Bid Bulletin #01

PROJECT: Shelton Public Schools
Additions & Alterations
Shelton, NE

DATE: March 21, 2014

**ADDITIONS & ALTERATIONS TO
SHELTON PUBLIC SCHOOLS
PROJECT NO. R-21113**

SHEET
PL100

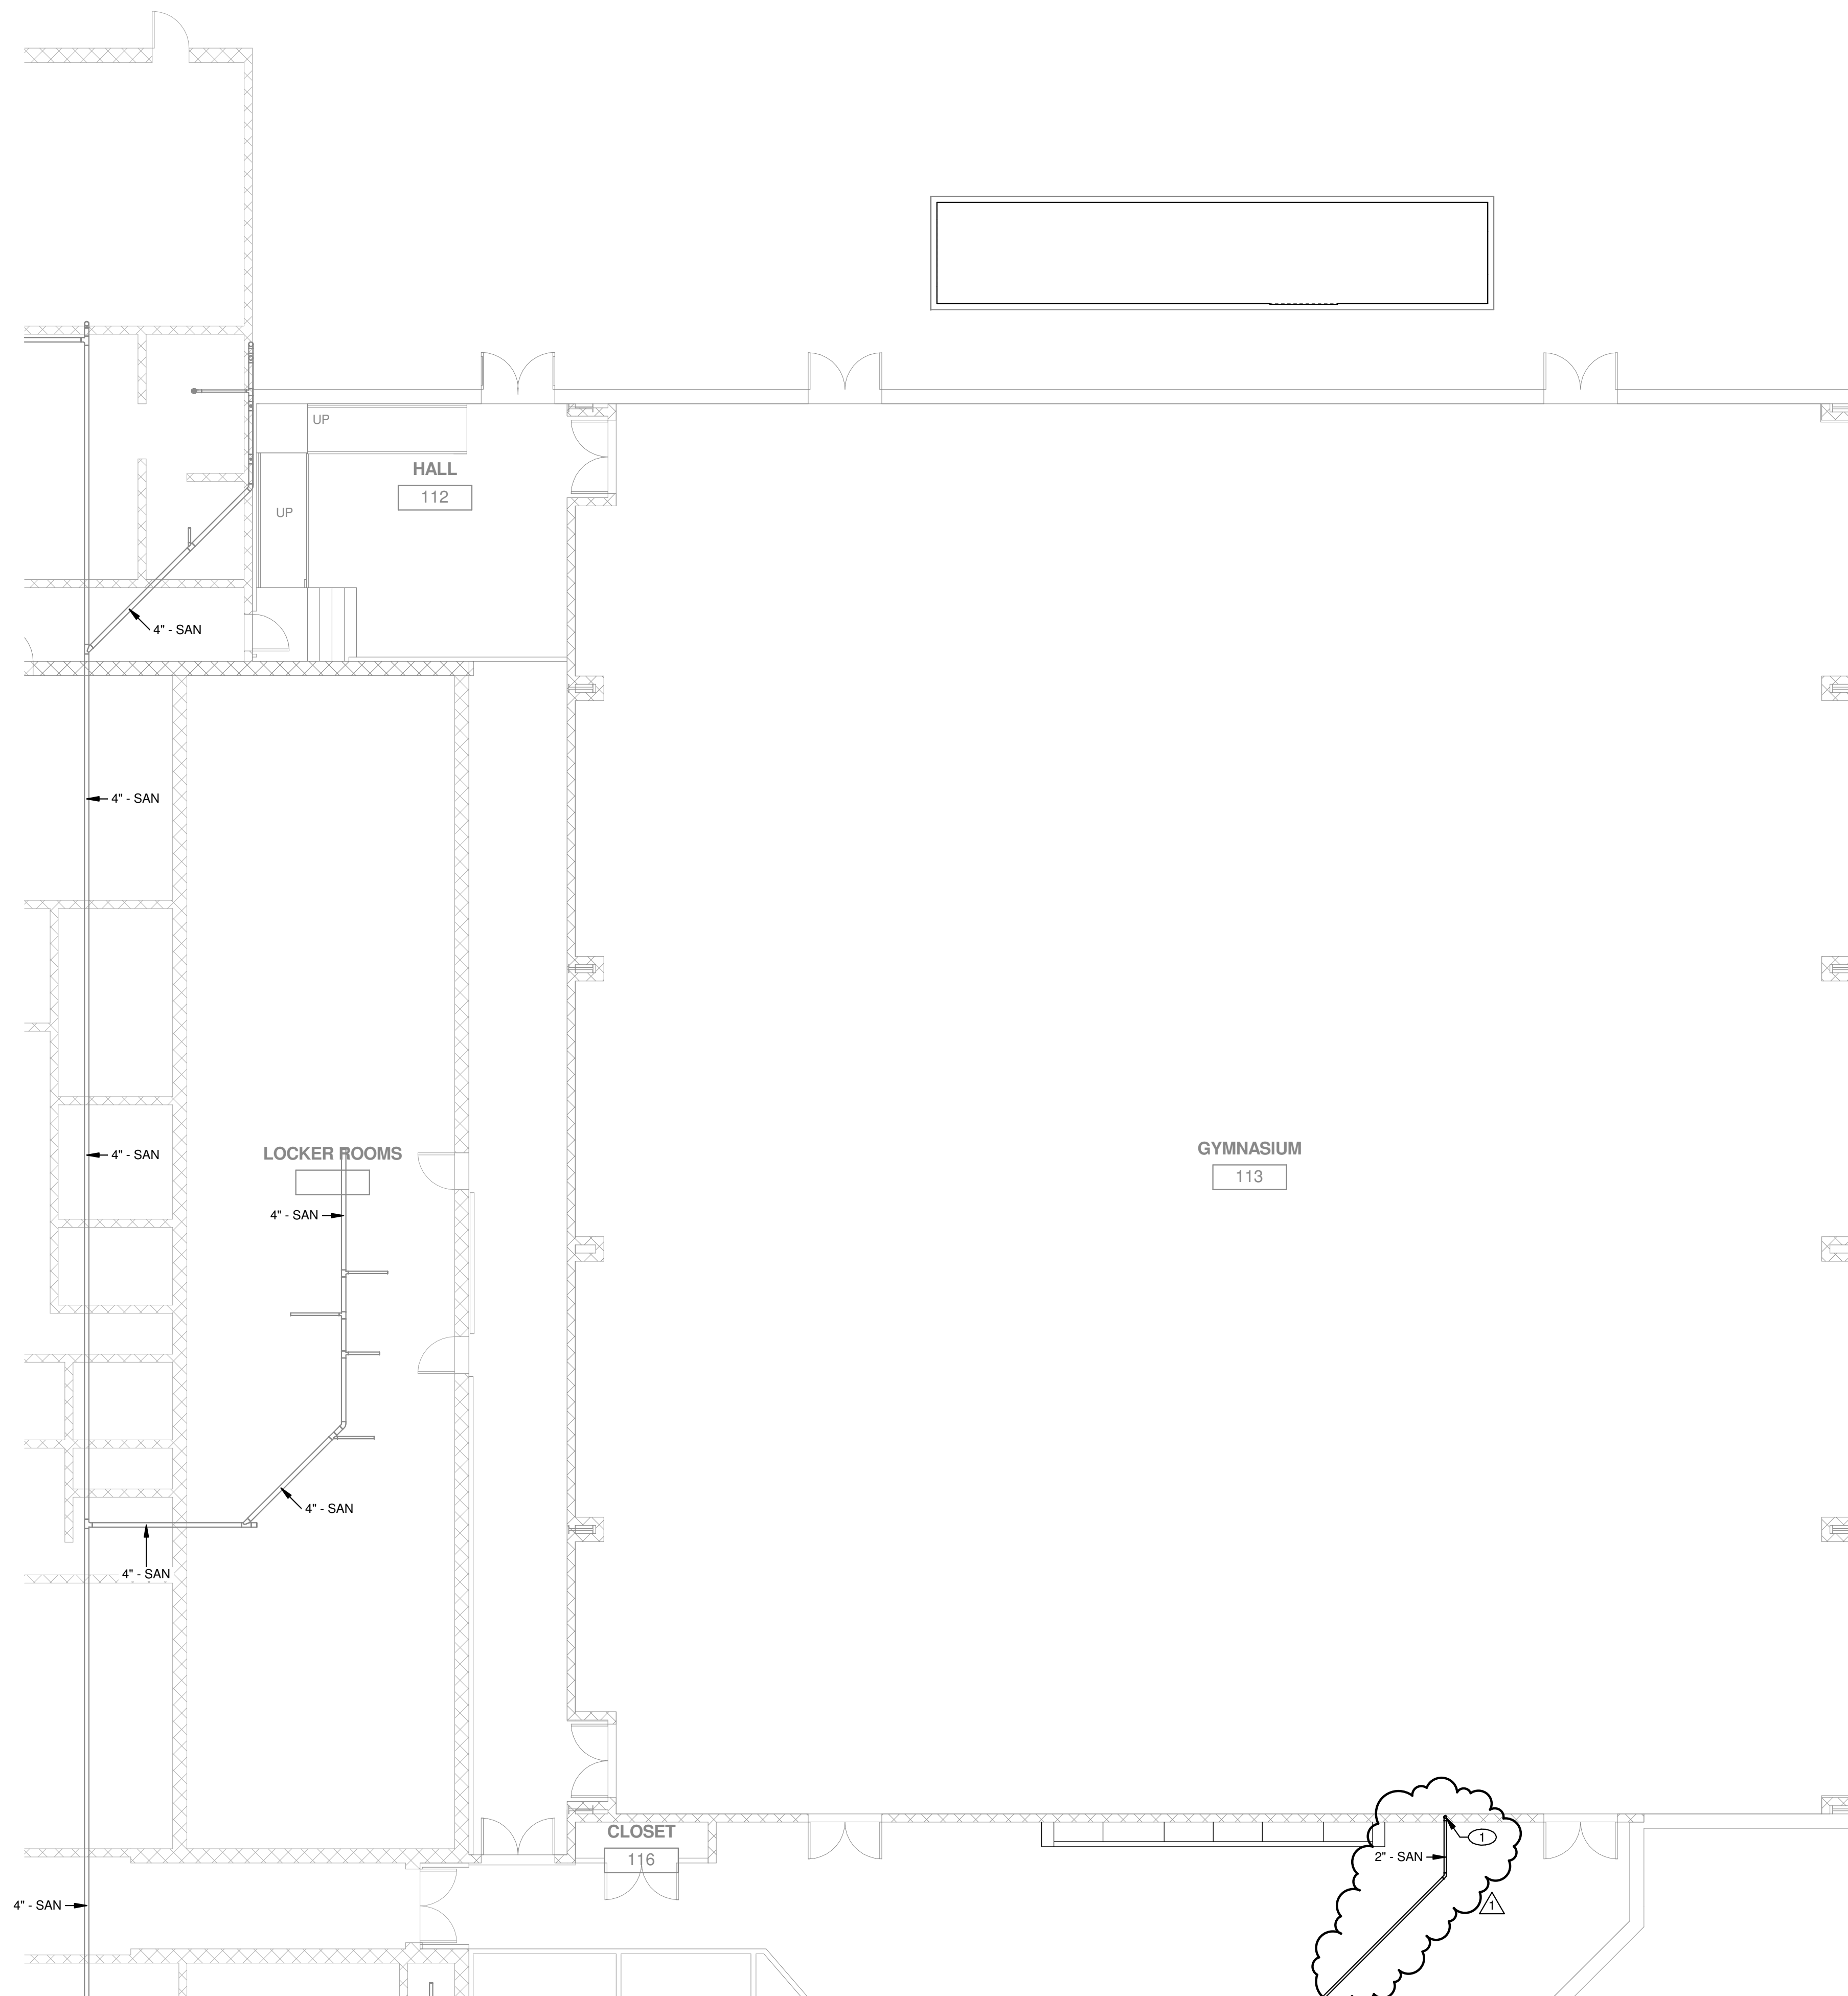
- a. Modify sanitary piping over to electric water cooler. Location of water cooler shifted West per Architectural Plans. See Reissued Sheet PL100 for revised piping. See Architectural Plans for new water cooler location.

SHEET
PL101

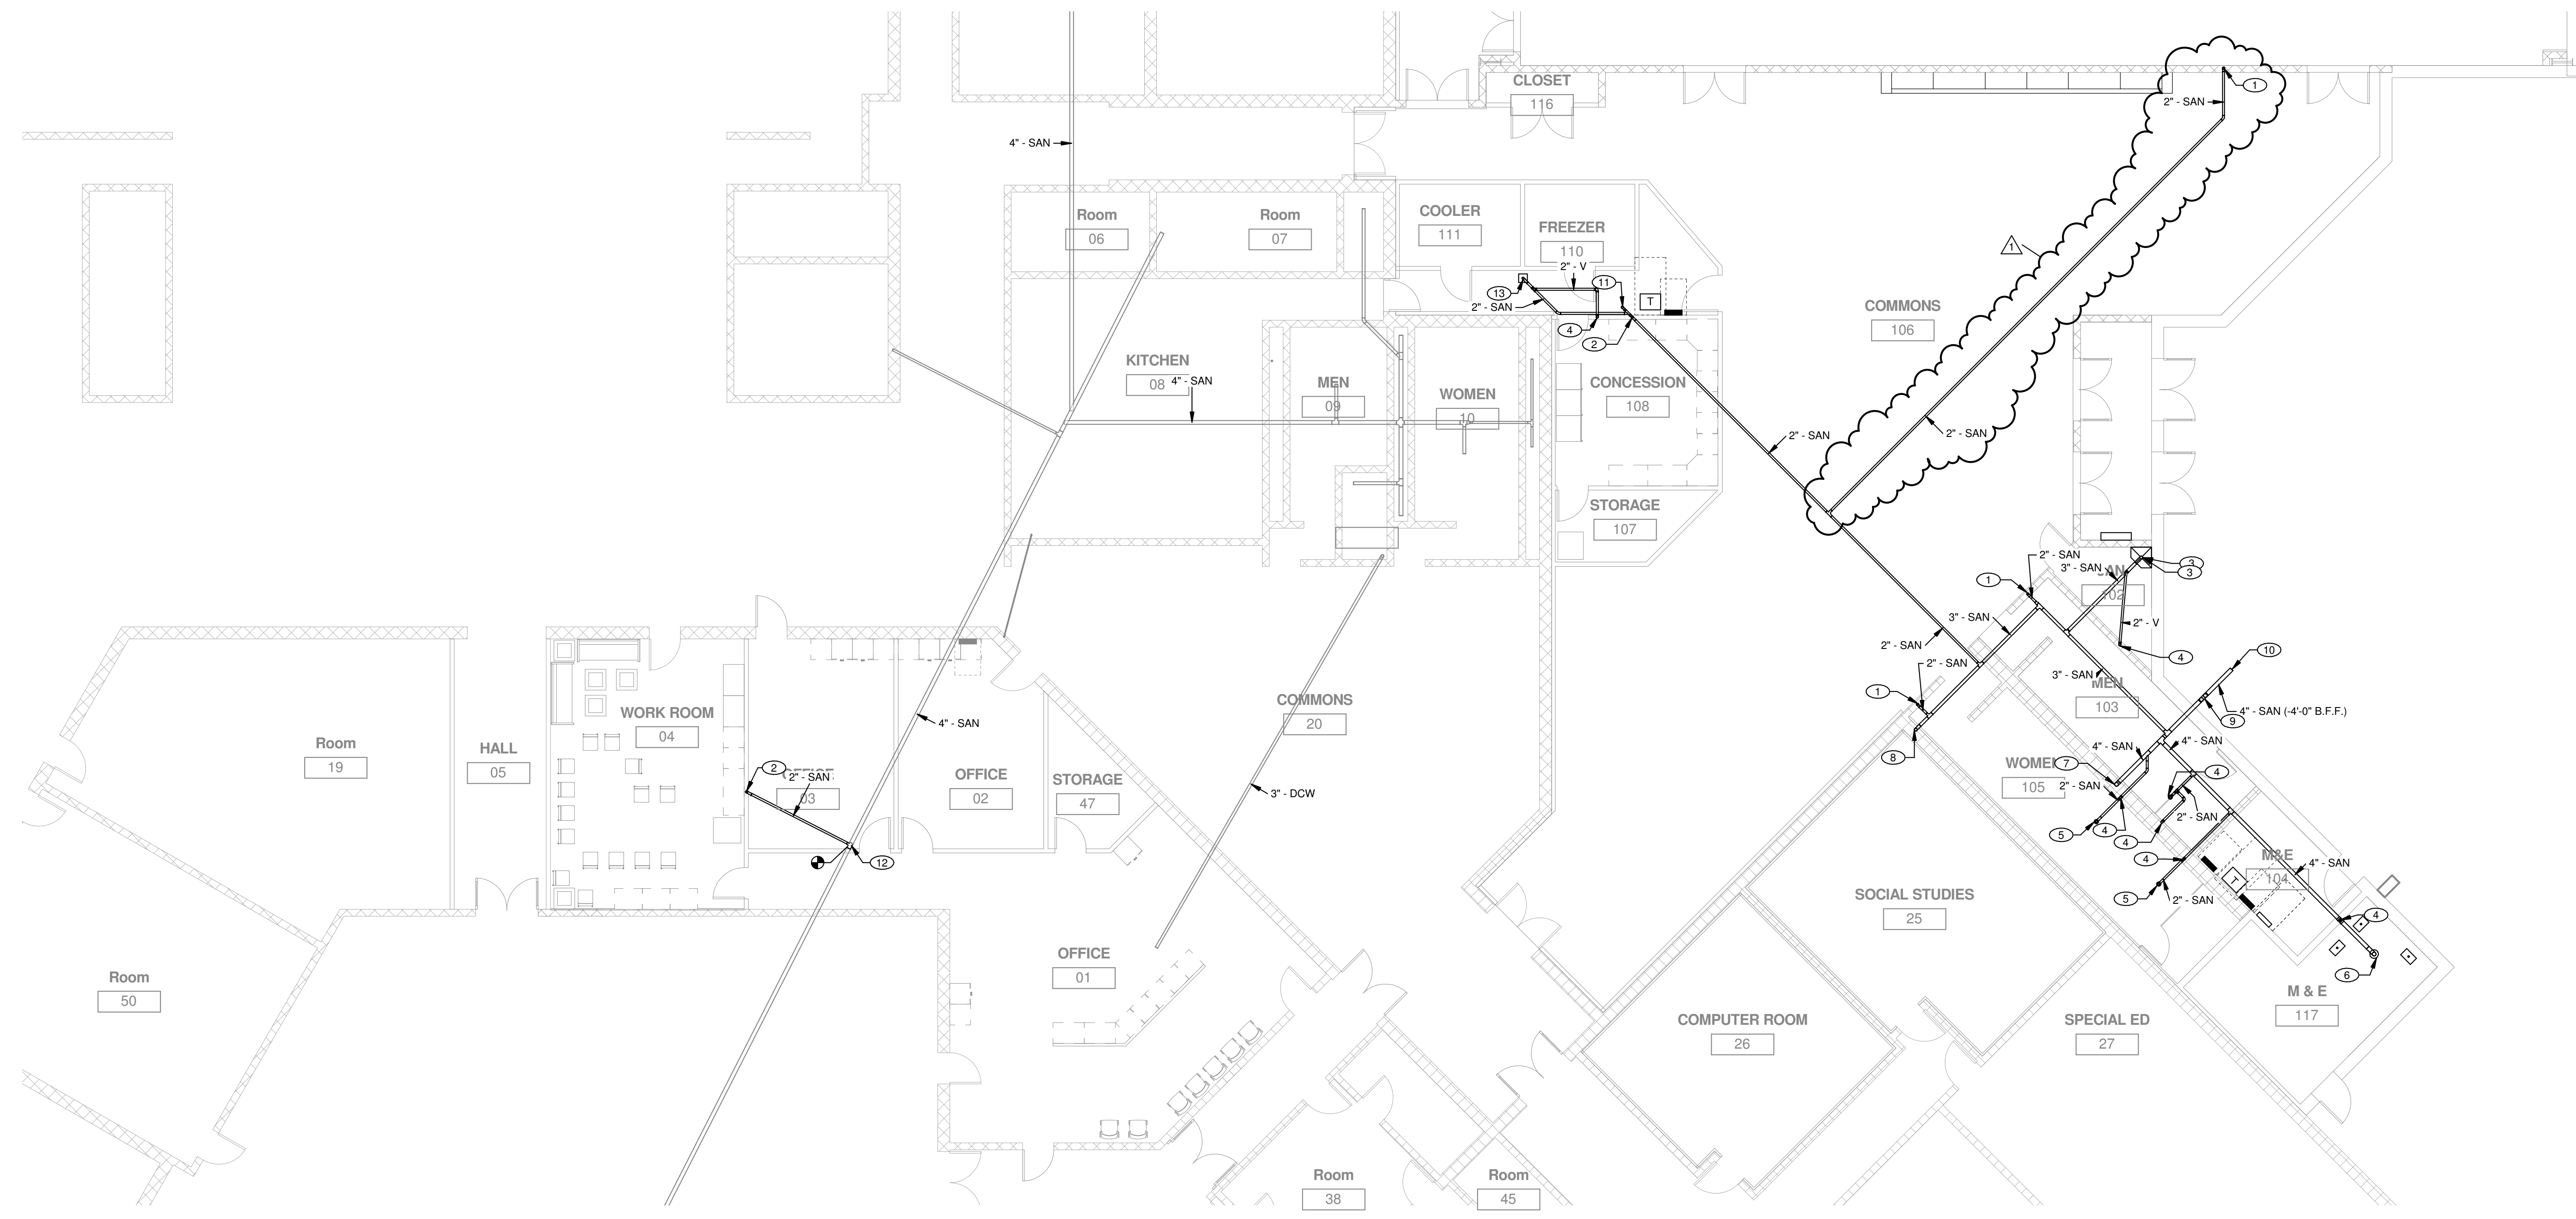
- M2: Drawing Sheet PL101, Foundation Plumbing - North
- a. Modify sanitary piping over to electric water cooler. Location of water cooler shifted West per Architectural Plans. See Reissued Sheet PL101 for revised piping. See Architectural Plans for new water cooler location.

SHEET
PL102

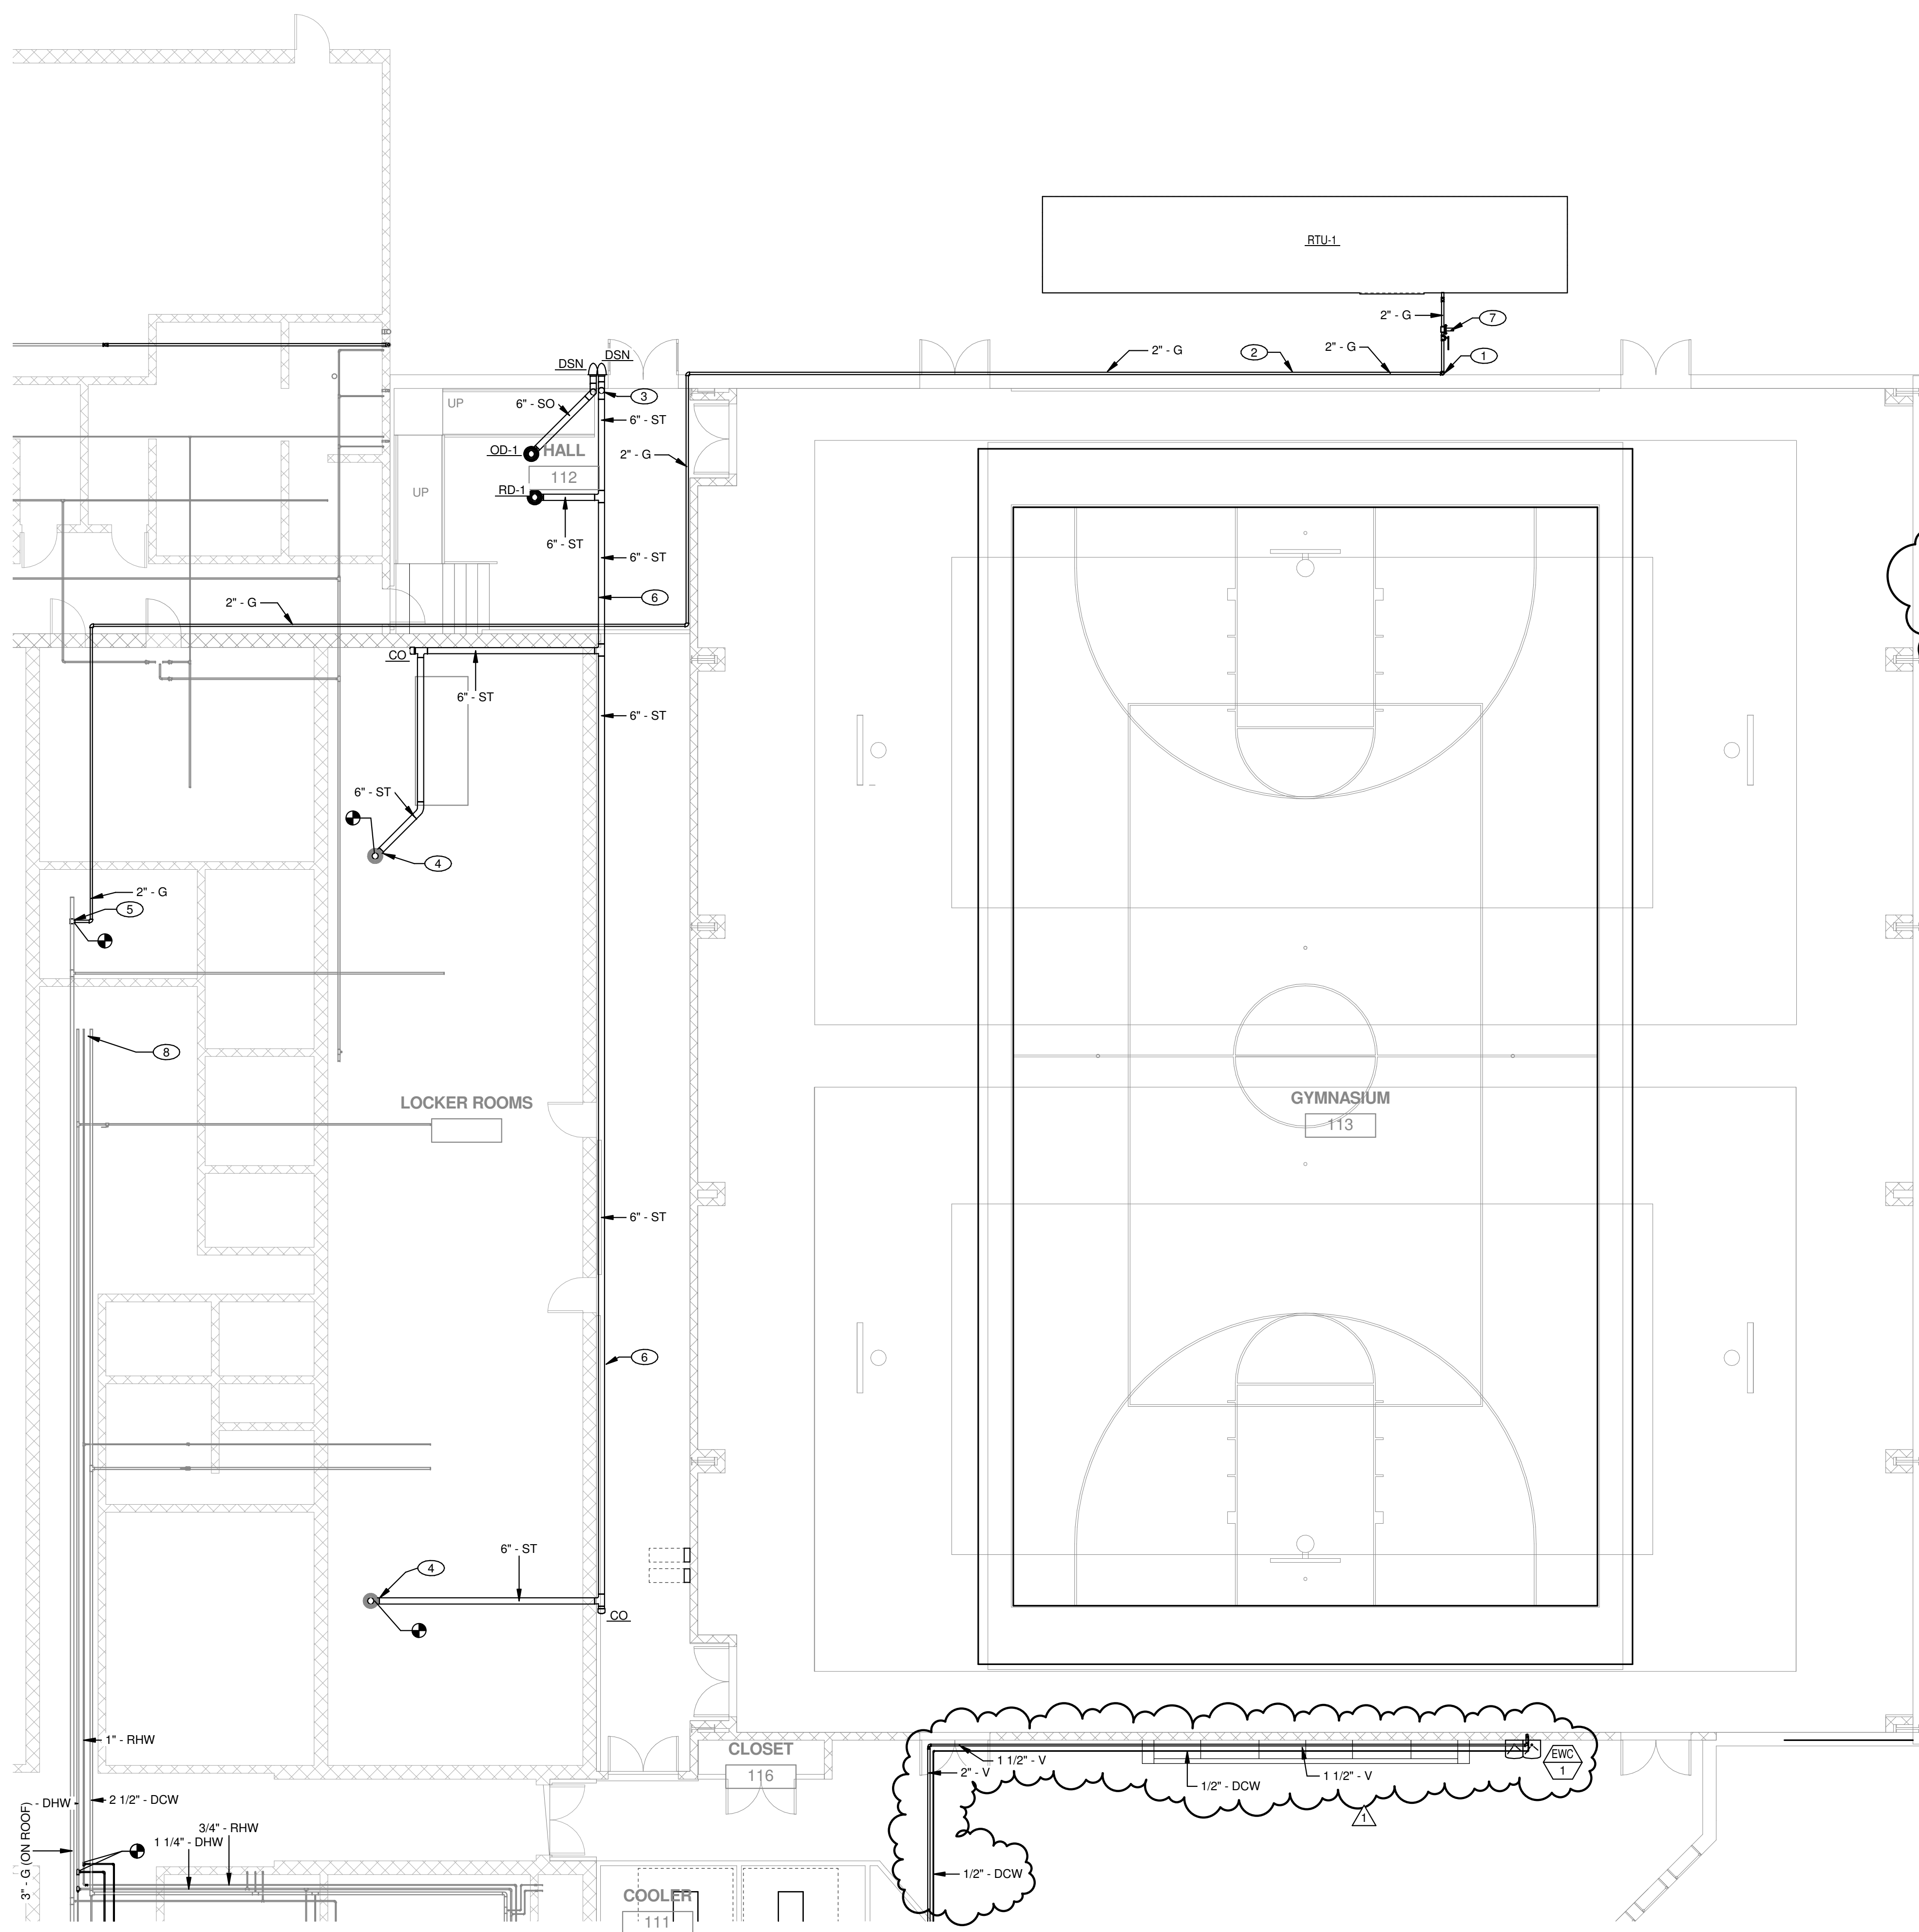
- M3: Drawing Sheet PL102, Level 1 Plumbing - South
- a. Modified domestic cold water and vent piping over to electric water cooler. Location of water cooler shifted West per Architectural Plans. See Reissued Sheet PL102 for revised piping. See Architectural Plans for new water cooler location.
